September 29, 1982

The Commission has issued the enclosed Amendments Nos. 113, 113, and 110 to Licenses Nos. DPR-38, DPR-47 and DPR-55 for the Oconee Nuclear Station, Units Nos. 1, 2 and 3. These amendments consist of changes to the Station's common Technical Specifications (TSs) in response to your request dated May 3, 1982, as revised in its entirety by letter dated August 11, 1982, and supplemented by letter dated August 16, 1982.

These amendments revise the TSs to allow full power operation of Oconee Unit 3 during fuel Cycle 7.

SAFETY EVALUATION BY THE OFFICE OF NUCLEAR REACTOR REGULATION

Figure 2.1-1C

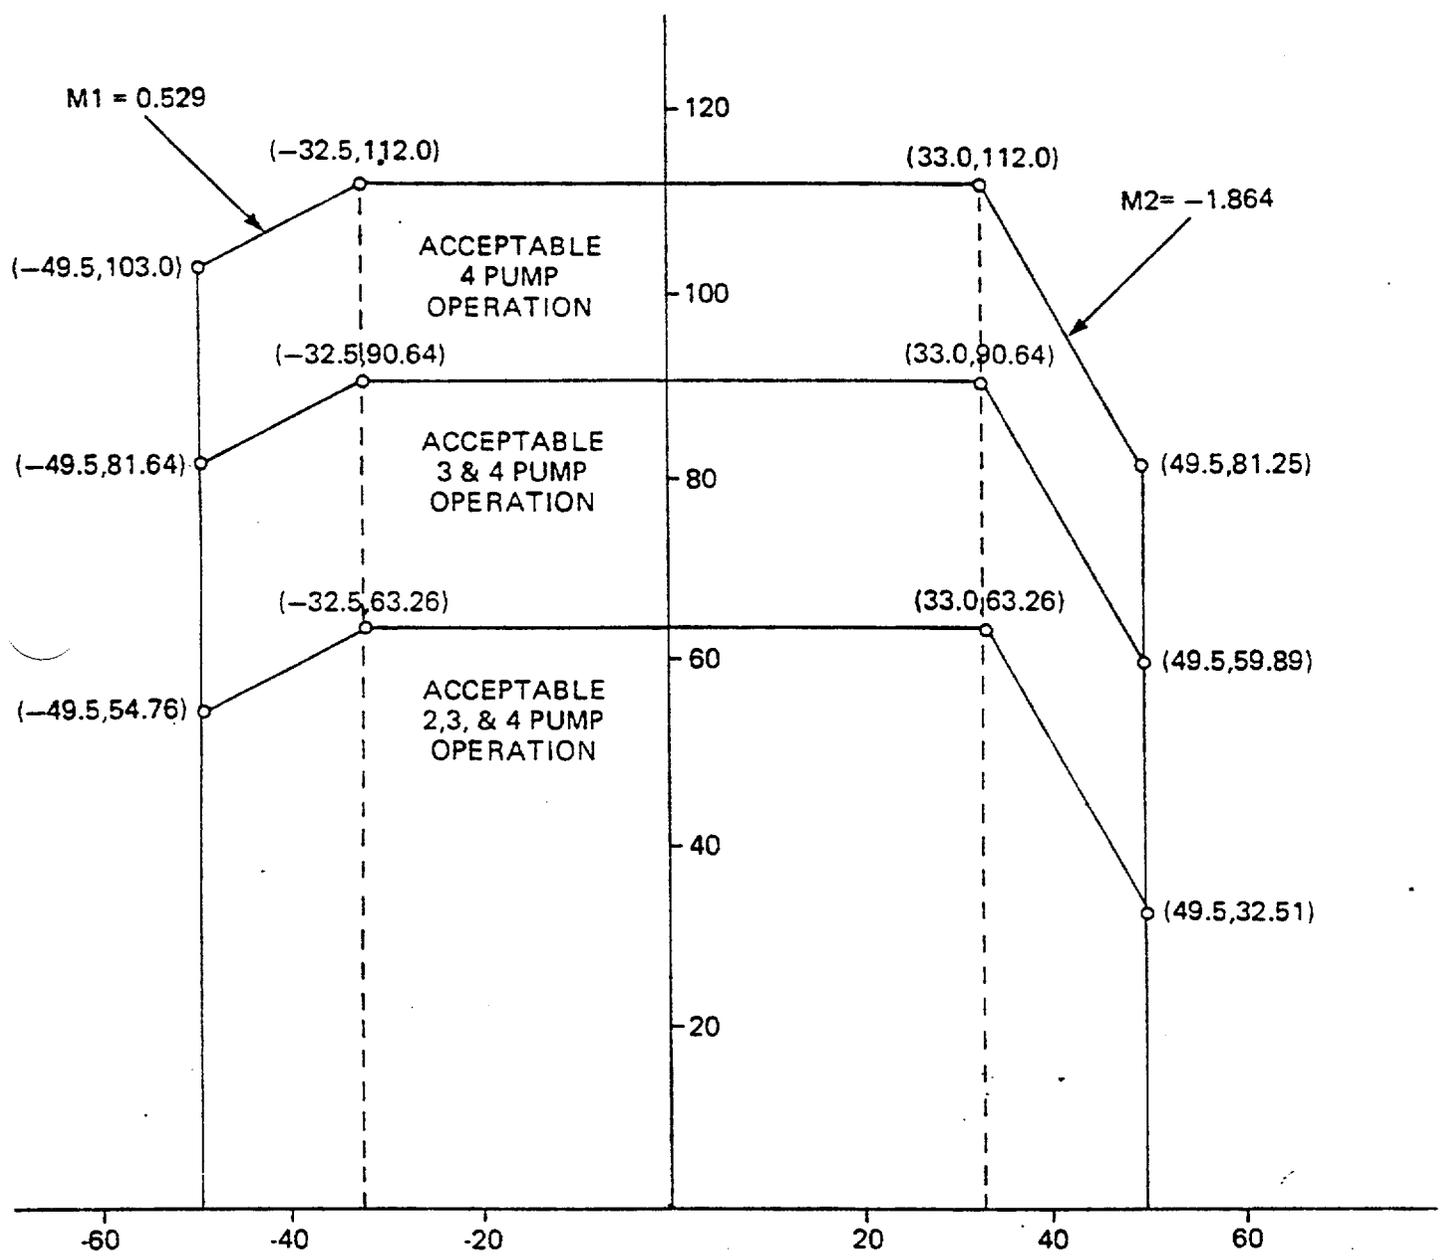
We have reviewed the proposed TS revisions for Cycle 7. These changes concern the (1) Core Protection Safety Limits of Specification 2.1; (2) Protective System Maximum Allowable Setpoints of Specification 2.3; and (3) Rod Position Limits of Specification 2.5.2. The limiting safety system settings and the limiting condition for operation have been established by approved methods. Changes which reflect the core thermal-hydraulic response still maintain the safety limit Departure from Nucleate Boiling Ratio (DNBR) criterion of 1.30. The control rod withdrawal limits for the various pump combinations and times in core life are presented as well as part length axial power shaping rod position limits. On the basis that previously

ROD POSITION LIMITS  
FOR FOUR-PUMP OPERATION  
FROM 0 TO 50 (+10, -0) EFPD  
UNIT 3  
OCONEE NUCLEAR STATION  
Figure 3.5.2-1C1

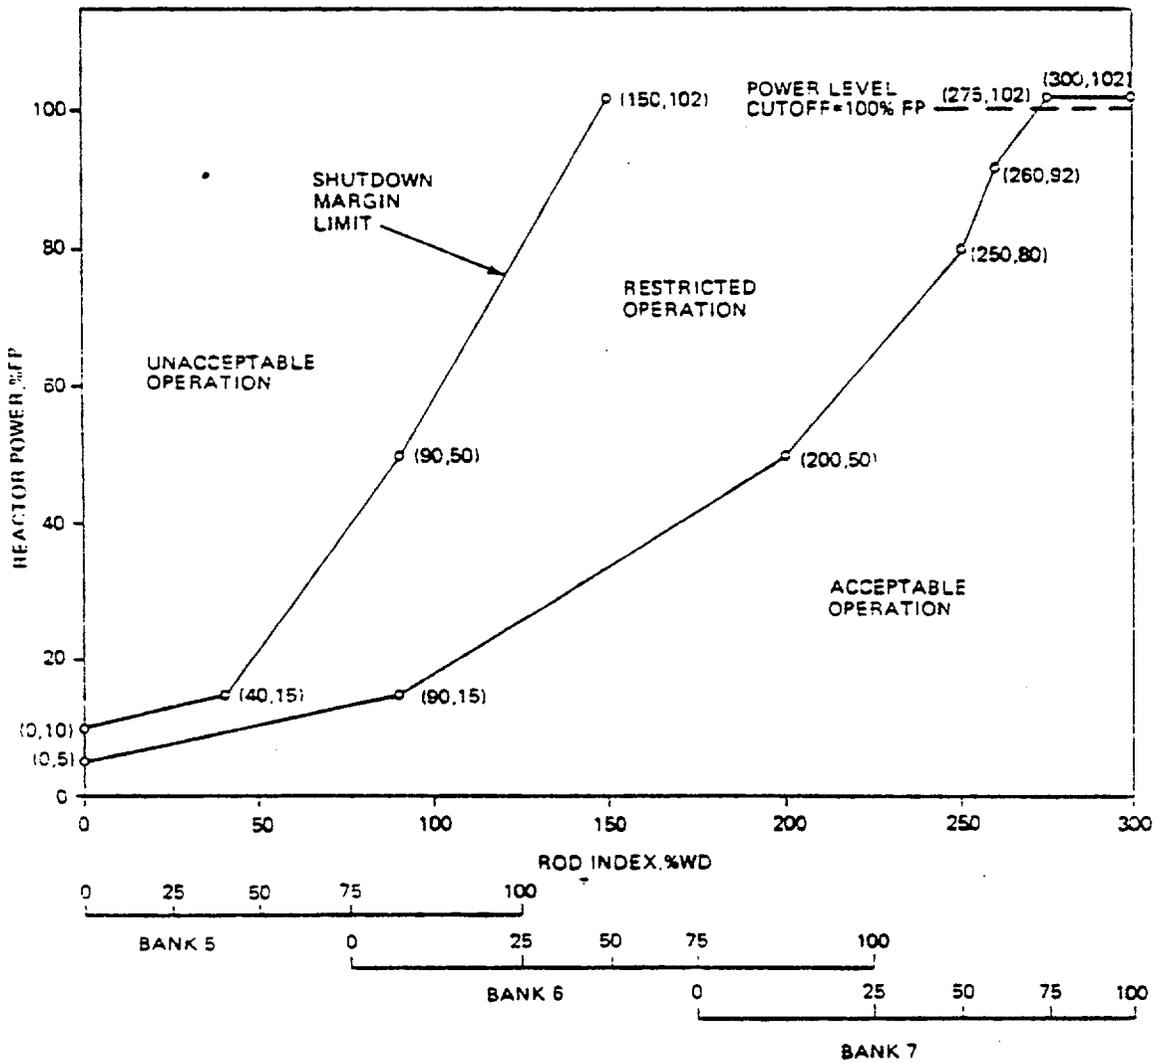
- c. Position limits are specified for regulating and axial power shaping control rods. Except for physics tests or exercising control rods, the regulating control rod insertion/withdrawal limits are specified on figures 3.5.2-1A1, 3.5.2-1A2, and 3.5.2-1A3 (Unit 1); 3.5.2-1B1, 3.5.2-1B2, and 3.5.2-1B3 (Unit 2); 3.5.2-1C1, 3.5.2-1C2, and 3.5.2-1C3 (Unit 3) for four pump operation, on figures 3.5.2-2A1, 3.5.2-2A2, and 3.5.2-2A3 (Unit 1); 3.5.2-2B1, 3.5.2-2B2, and 3.5.2-2B3 (Unit 2); figures 3.5.2-2C1, 3.5.2-2C2, and 3.5.2-2C3 (Unit 3) for three pump operation, and on figures 3.5.2-2A4, 3.5.2-2A5, and 3.5.2-2A6 (Unit 1); 3.5.2-2B4, 3.5.2-2B5, and 3.5.2-2B6 (Unit 2); figures 3.5.2-2C4, 3.5.2-2C5, and 3.5.2-2C6 (Unit 3) for two pump operation. Also, excepting physics tests or exercising control rods, the axial power shaping control rod insertion/withdrawal limits are specified on figures 3.5.2-4A1, 3.5.2-4A2, and 3.5.2-4A3 (Unit 1); 3.5.2-4B1, 3.5.2-4B2, and 3.5.2-4B3 (Unit 2); 3.5.2-4C1, 3.5.2-4C2, and 3.5.2-4C3 (Unit 3).
